City of Biddeford
Planning Board
November 03, 2021 6:00 PM City Hall
Council Chambers, & via Zoom
Nov 3, 2021 06:00 PM Eastern Time (US and Canada)
Topic: Planning Board Meeting

- 7.C. 2021.31 Review a Preliminary 6-Lot Cluster Subdivision Application for Ginger Hill Design + Build at 918 Pool Road (Tax Map 4, Lot 48) in the Coastal Residential (CR) and Rural Farm (RF) Zones.

[2.0 Response to Engineer Review.pdf](#)

- 7.D. 2021.30 Review a Preliminary 6-Lot Cluster Subdivision for Ginger Hill Design + Build at 158 Oak Ridge Road (Tax Map 4, Lot 57) in the Rural Farm (RF) Zone.

C2.3

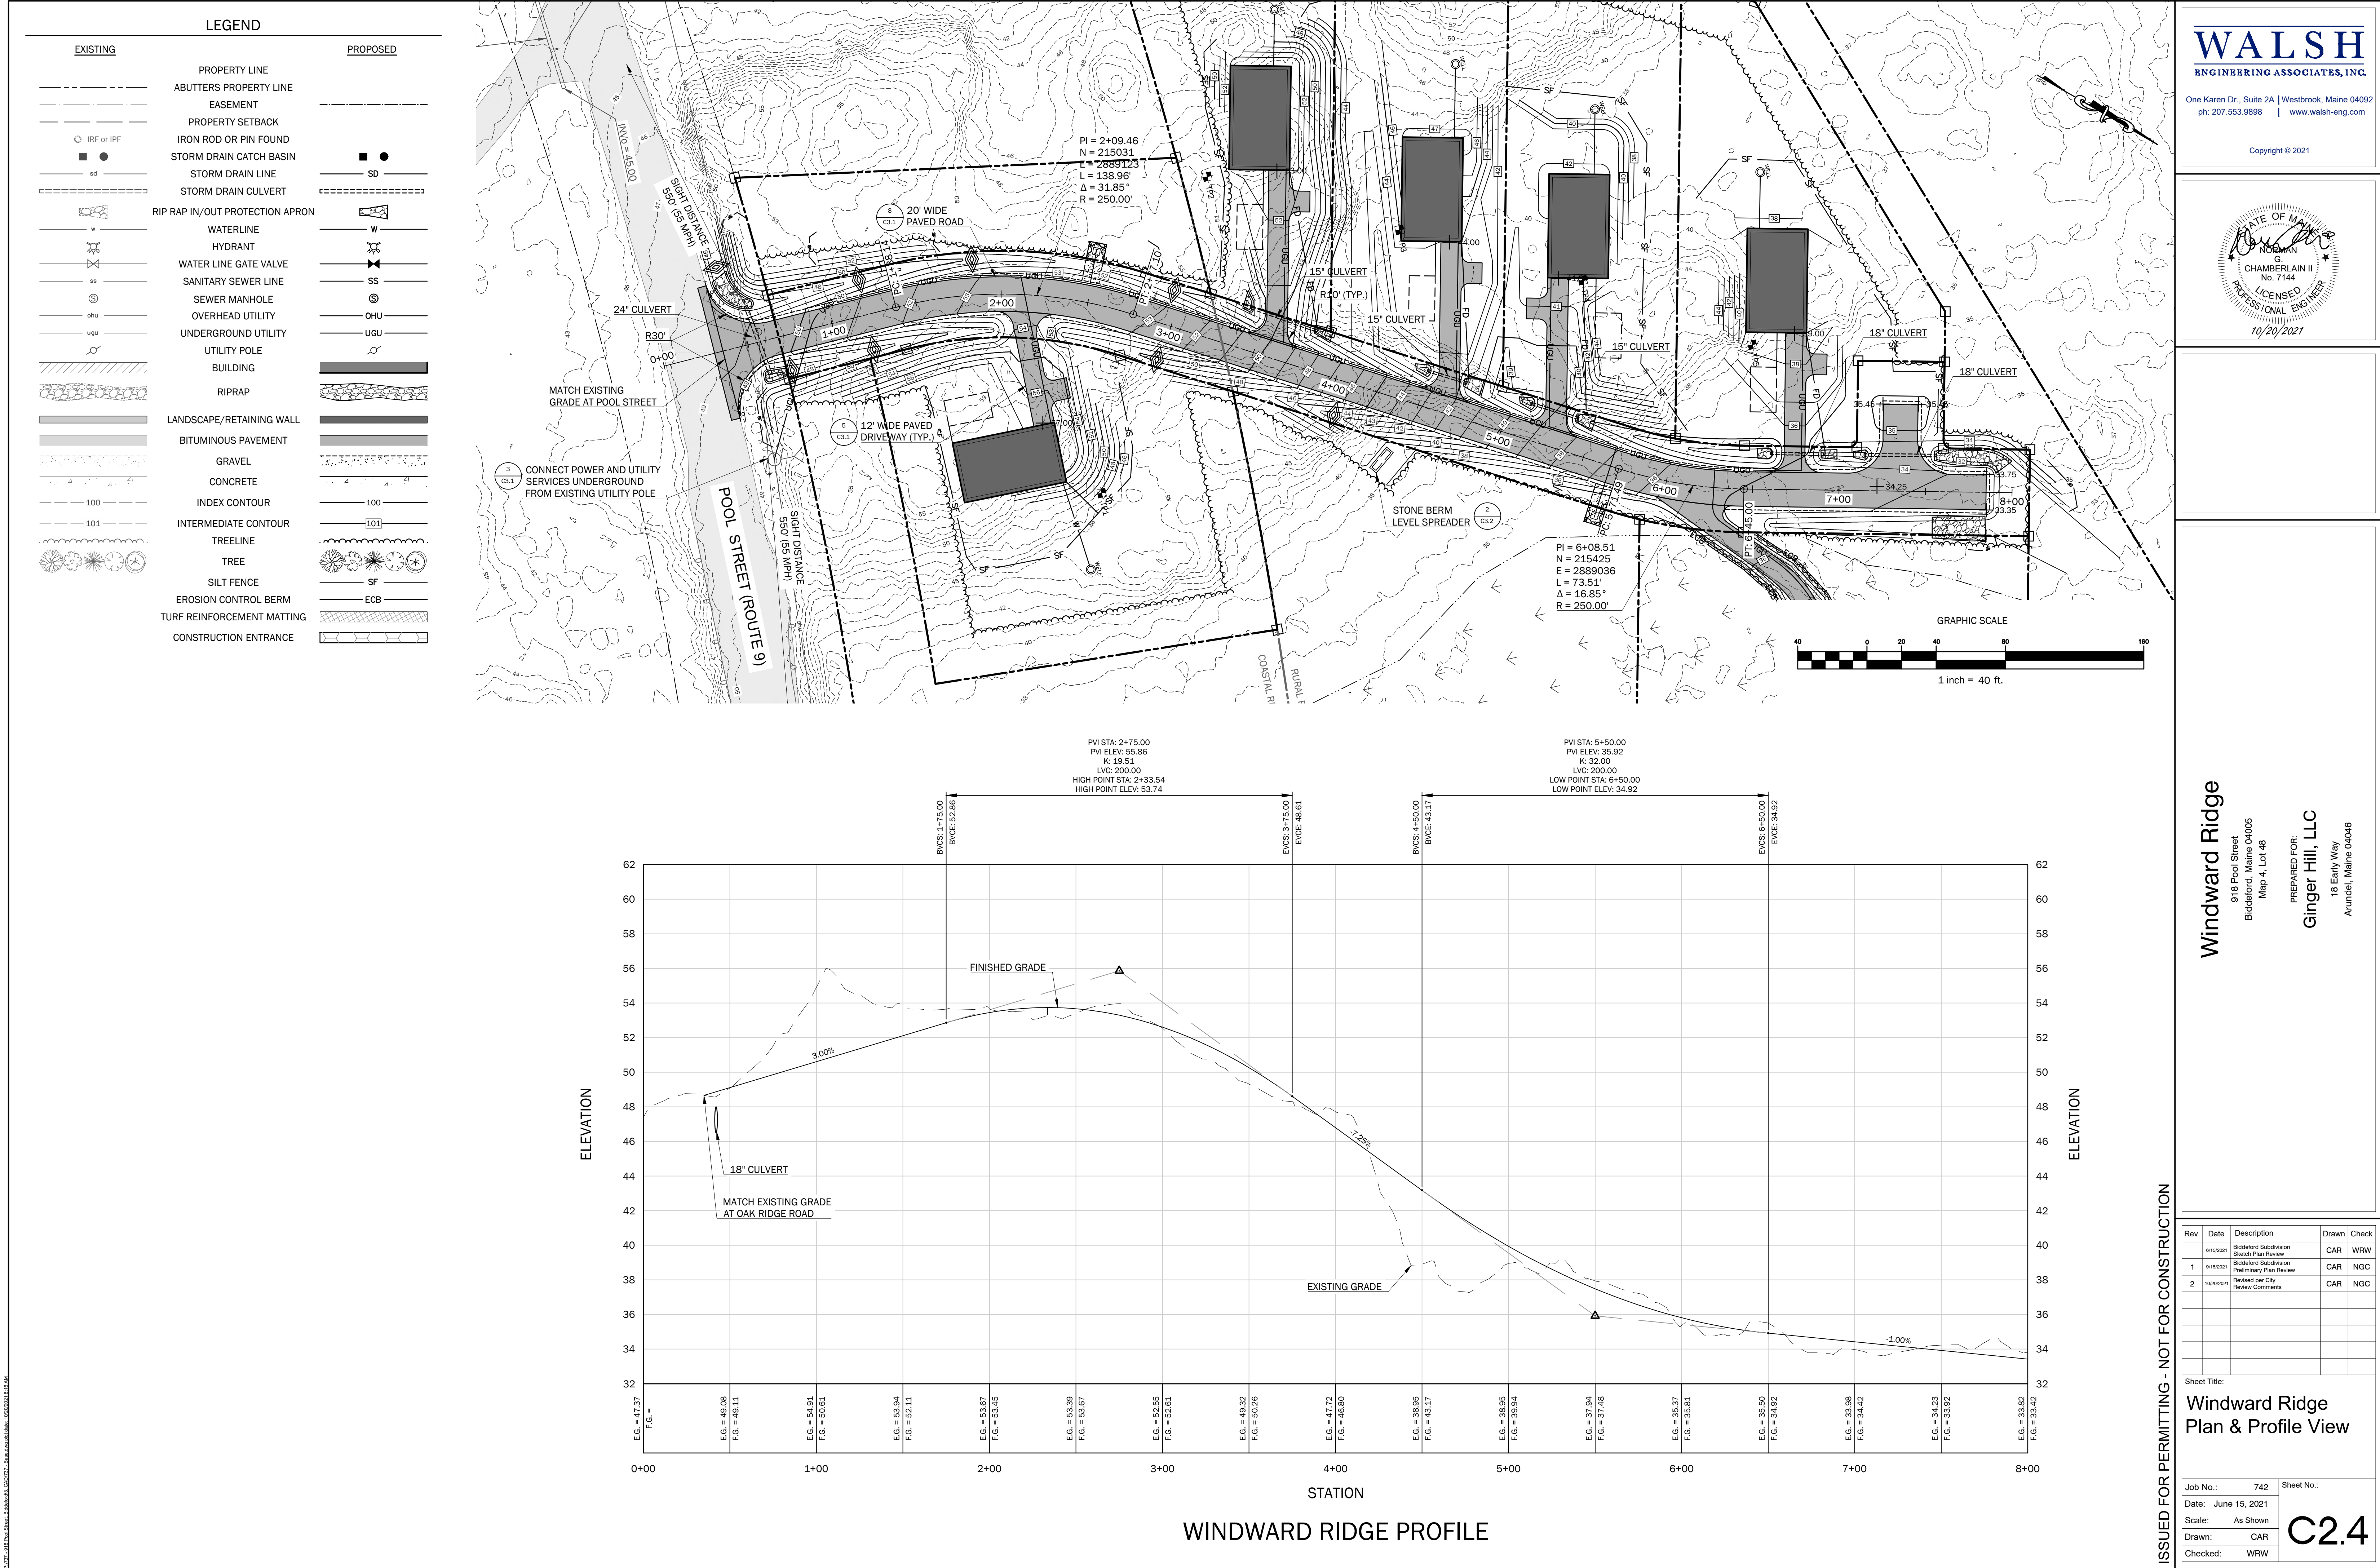
The proposed roadway from Pool Street incurs a great deal of clearing and grading (Sheet C2.3) outside of its Right-Of-Way, that will result in a significant hole in what is now is dense woodland edge. Plantings of trees and shrubs should be considered to either side of the entrance within the lot and open space land that would provide an adequate screen and soften the associated clearing.

C.1.b. The response indicates the existing culvert at the site entrance will be replaced. Drawing C-2.4 shows a new 24" culvert in plan view and an 18" culvert in the profile.

4. C2.3 & C2.4 – Grading, Drainage, and Erosion Control Plan and Plan/Profiles
- a. A minimum 1 foot of cover has been provided over both culverts.
 - b. Temporary erosion control measures have been added to the plan.

- i. See detail 9 on sheet C3.1 for more information regarding the wetland crossing culvert. The driveway will not be overtopped during any modeled storm event.
